UNITED STATES PATENT AND TRADEMARK OFFICE

APPLICATION NO.	FILING DATE	FIRST NAMED INVENTOR	ATTORNEY DOCKET NO.	CONFIRMATION NO.
10/820,648	04/08/2004	Ata Zadehgol	P18563 (INTEL29)	8505
6980	7590	01/12/2006	EXAMINER	
TROUTMAN SANDERS LLP 600 PEACHTREE STREET , NE ATLANTA, GA 30308				GLENN, KIMBERLY E
		ART UNIT		PAPER NUMBER
		2817

Office Action Summary	Application No.	Applicant(s)	
	10/820,648	ZADEHGOL ET AL.	
	Examiner	Art Unit	
	Kimberly E. Glenn	2817

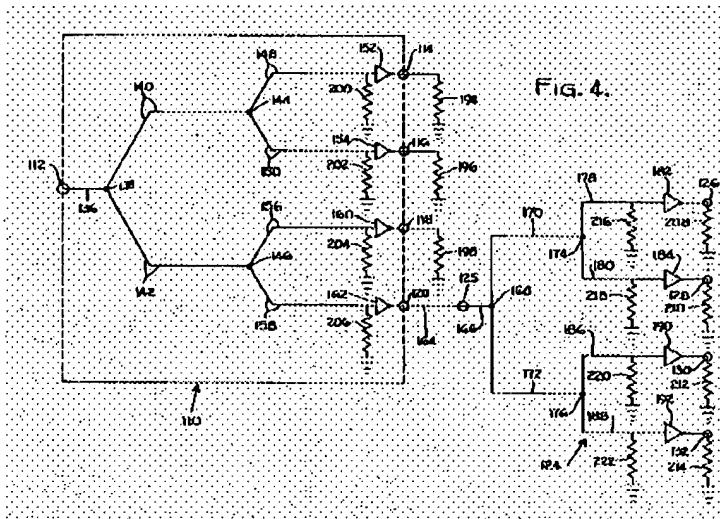
Barczys disclose in figure a first multicoupler 100 connected to an input signal 112 and having a first output 118 and a second output 120; a termination resistor 204 connected to the first output and second multicoupler 124 connected to the second output 120 and having a plurality of outputs. A plurality of amplifiers are connected to the plurality of outputs. The amplifiers are connected to matching resistors. Inherently, transmission lines connected between the amplifier and the matching resistors.

Applicant states in column 6; lines 21-22, with reference to the figure 3, that impedance match exists within the network, and that the length of the transmission lines cables are irreverent.

Thus, all the limitation of the claims are shown with the exceptions of the output having equal phase and equal magnitude, the pie type impedance matching body section having a wedge shaped geometry and the pie type impedance matching section comprising a conductive material.

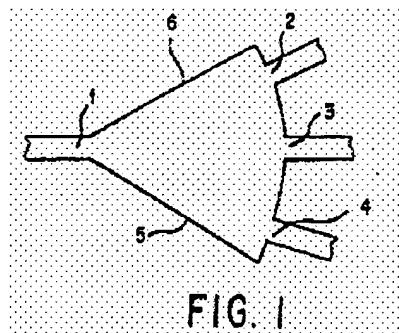
Abouzahara et al disclose in figure 1 a fan (pie) shaped divider/combiner comprising a plurality of ports (1-4). Abouzahara et al disclose in the abstract the planar configuration provides to a balanced phase and amplitude outputs.

One of ordinary skill in the art would have found it obvious to replace the second multicoupler of Barczys with the divider/combiner as taught by Abouzahara et al since the examiners takes notices of the equivalence of the multicoupler and the divider/
